INTERMEDIATE AXLE SHAFT FOR MODEL 44 8FD

AXL-TEC-11
TECHNICAL

DATE: July 14, 1993

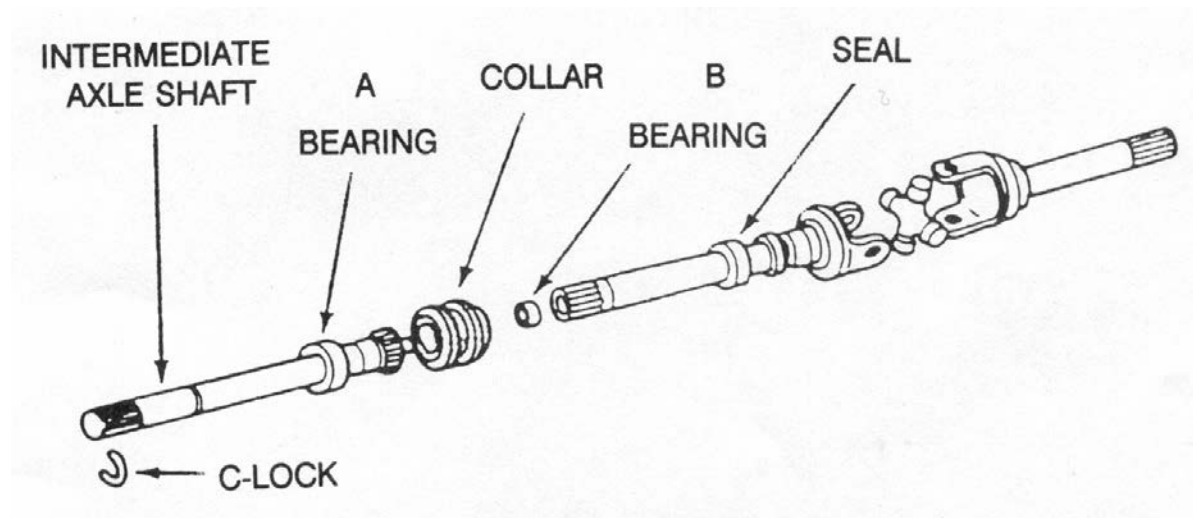
When replacing the Intermediate Axle Shaft, the needle bearing "B" should be replaced with synthetic bushing, 43337, contained in the above-mentioned kit, 75265X.
